STATE OF WASHINGTON
DEPARTMENT OF ECOLOGY

Re: No Further Action at the following Site – Groundwater Model Remedy No. 5:

- **Site Name:** Unocal Bulk Plant 0082
- **Site Address:** 1329 West Woodin Avenue, Chelan
- **Cleanup Site ID:** 4415
- **Facility/Site ID:** 345
- **VCP Project ID:** CE0428

Site Plan

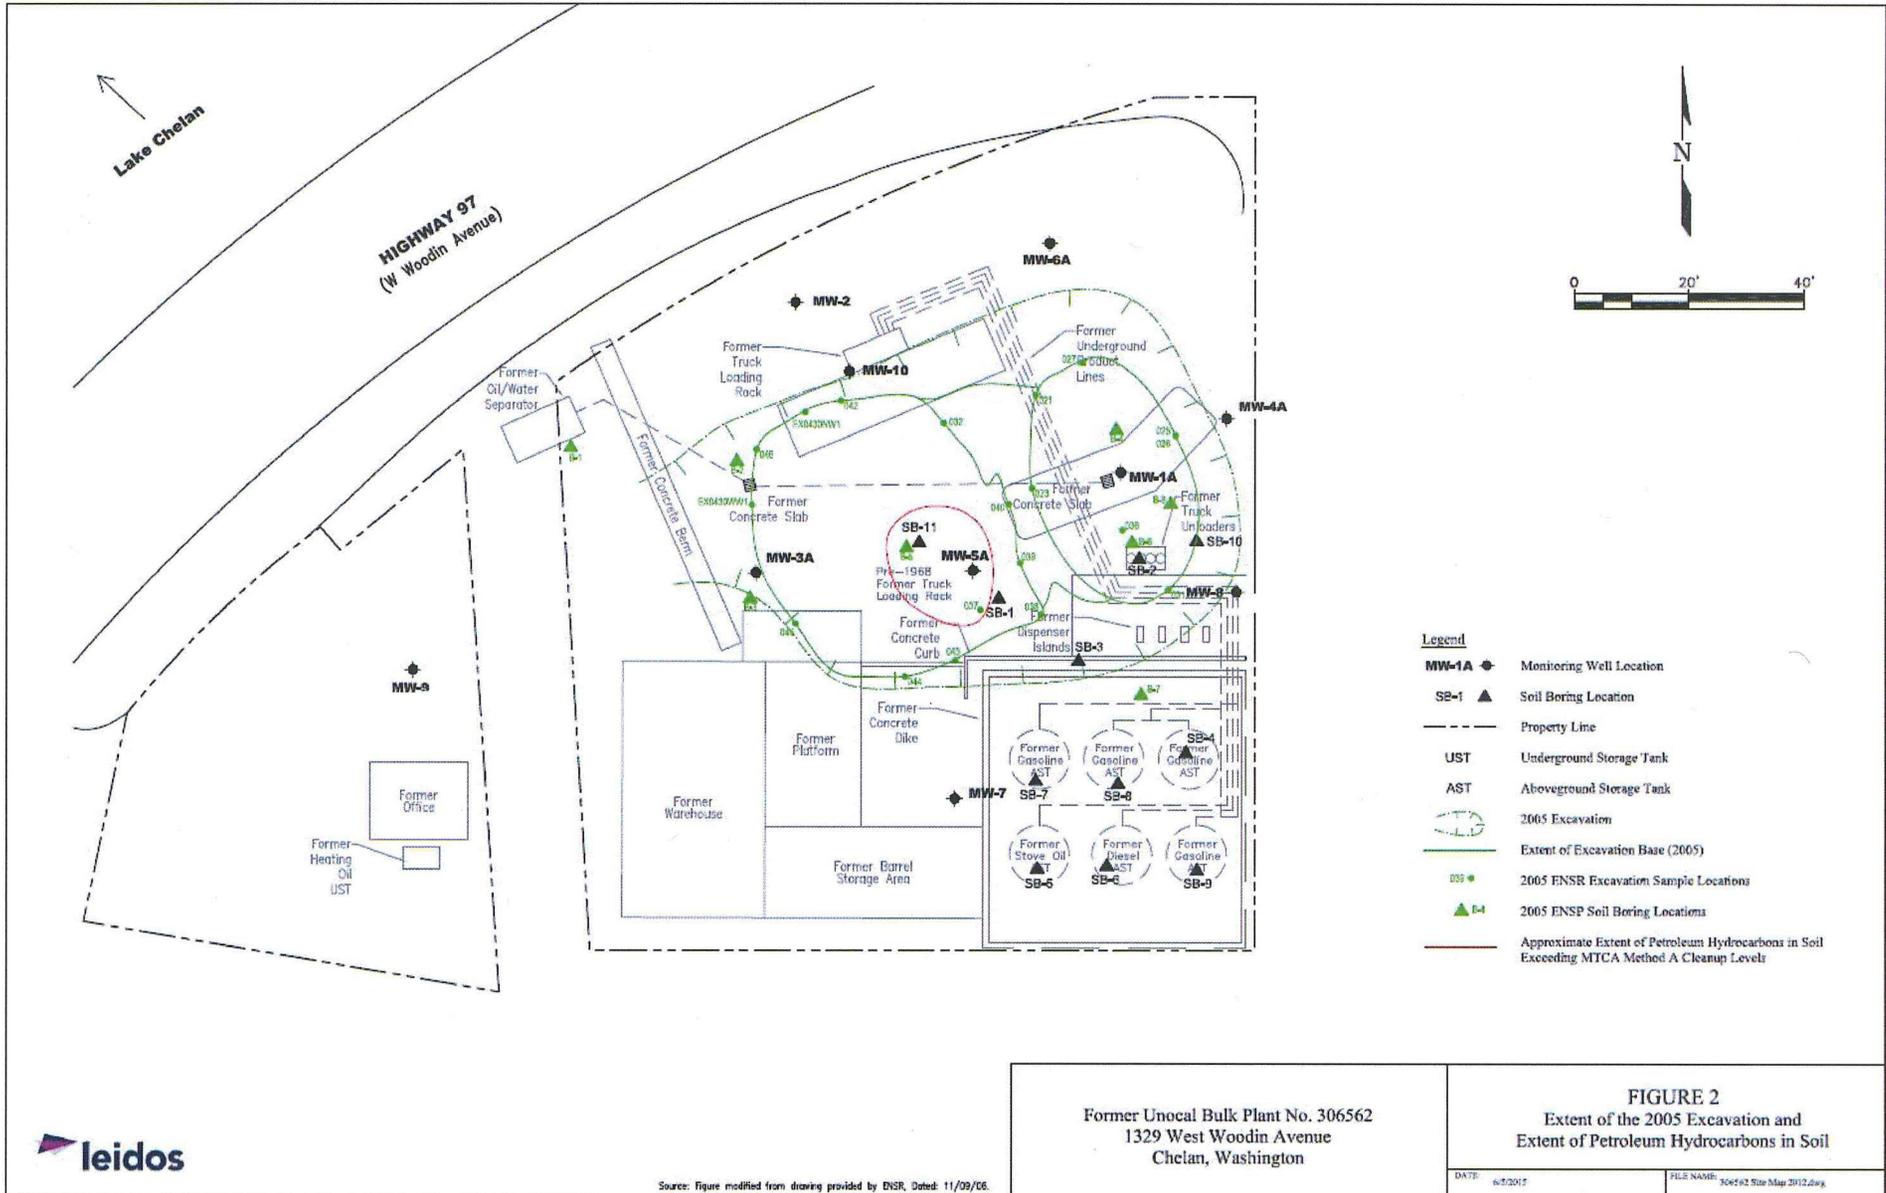
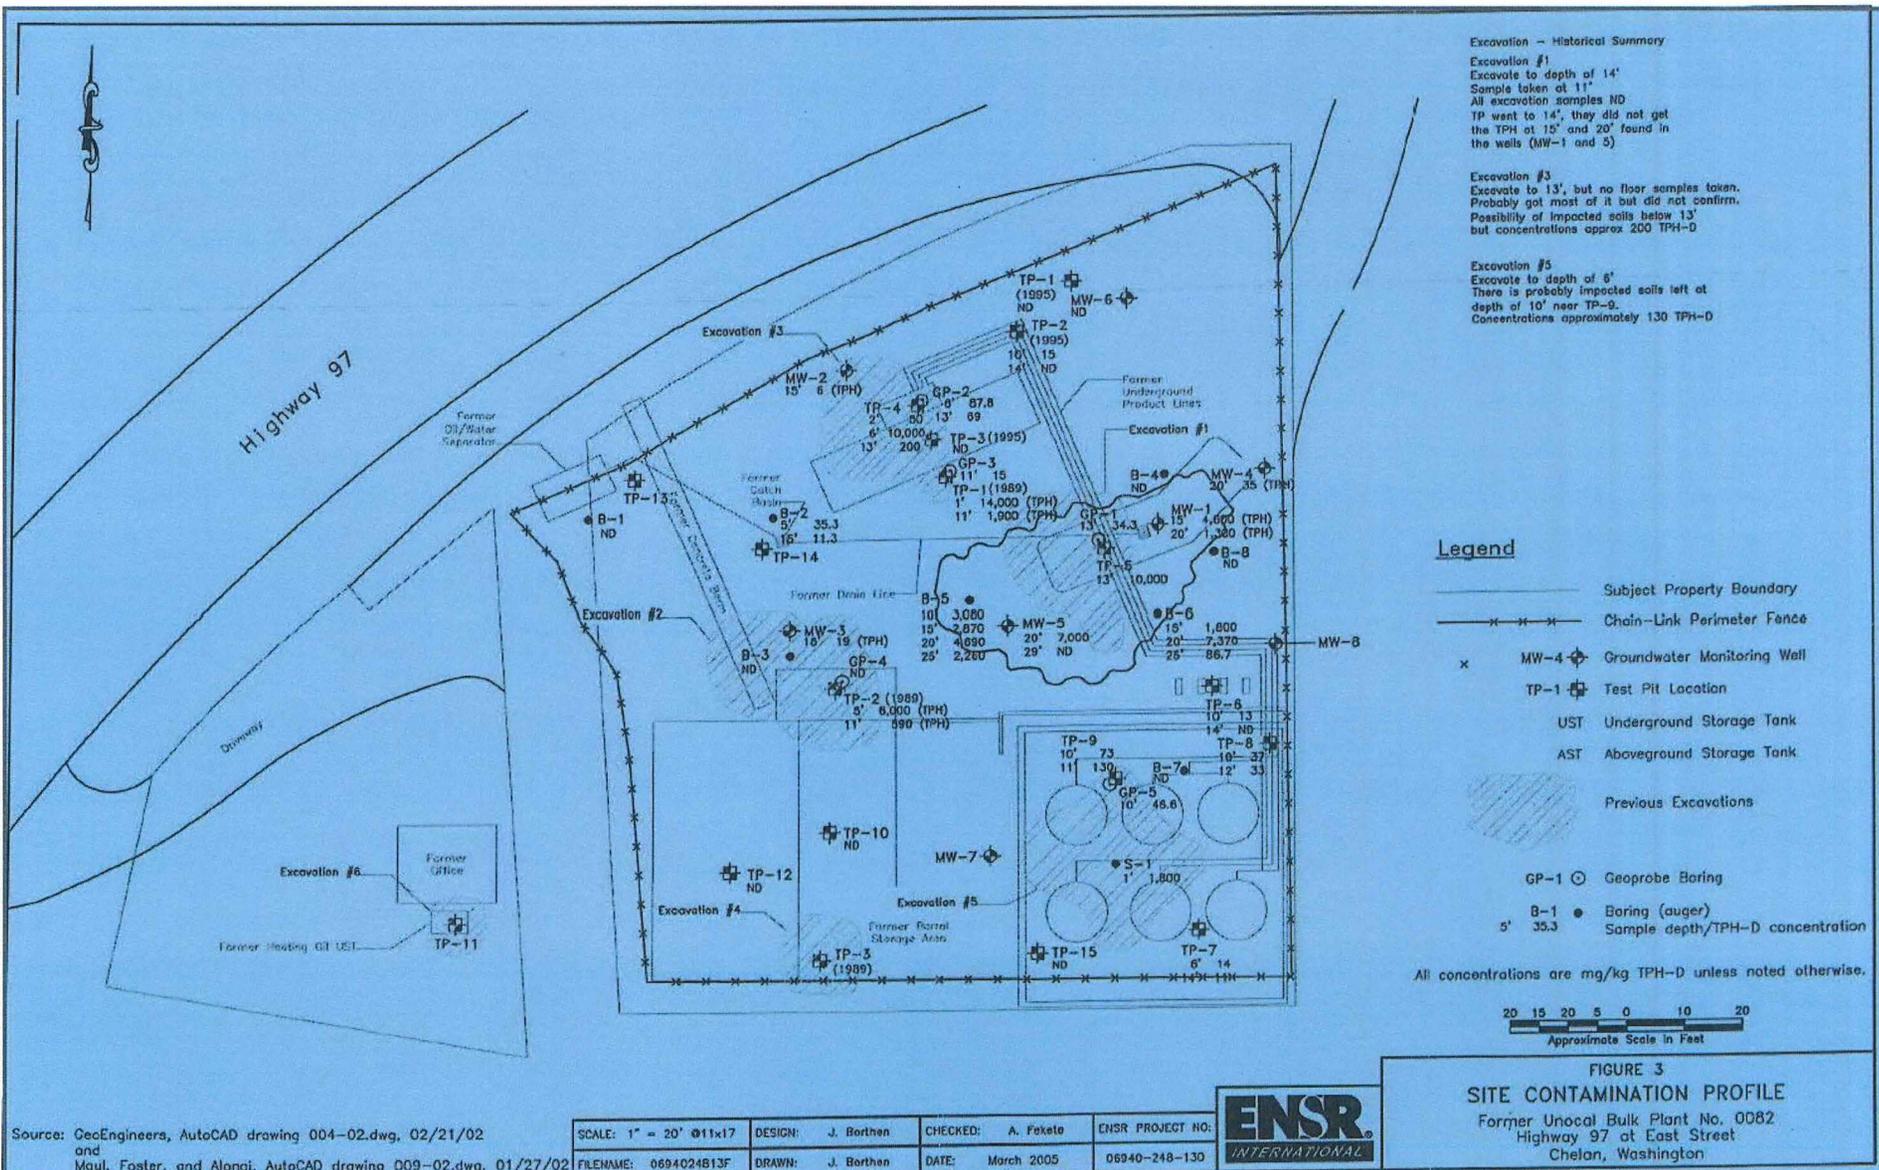
Ecology has determined your characterization of the Site is sufficient to establish cleanup standards and select a cleanup action. A Site Plan is presented in **Enclosure A**.
